# Access Compliance Report

## Public Rights-of-Way (Curb Ramps)

| Intersection ID: 49249                  | Main Street: BOOMERANG_WY | Cross Street: PROSPERITY_VIEW_DR        | Location: SW           |
| ADA ID: 96D3FA13B6C9                    | Ramp Type: BlendTrans1    | Initial Pass/Fail: Pass                 | Overall Compliance: No |

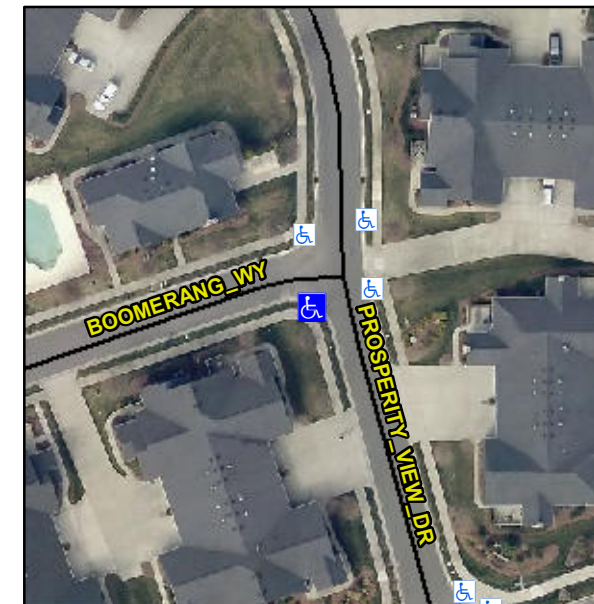
**Not Found, R302.7, R302.7.2, R304.5.4**

| Compliance | Description           | Data   | Compliance | Description                 | Data   |
|------------|-----------------------|--------|------------|-----------------------------|--------|
| No         | Gutter Ponding?       | Yes    | No         | Gutter Slope (%)            | 10.6   |
| No         | Gutter Lip Ht (in)    | 0.5    | Yes        | Gutter X Slope (%)          | 0.7    |
|            |                       |        | No         | Curb Slope (%)              | 12.3   |

**Remove & Replace Curb Slope and Extend Ramp. Remove & Replace Gutter.**
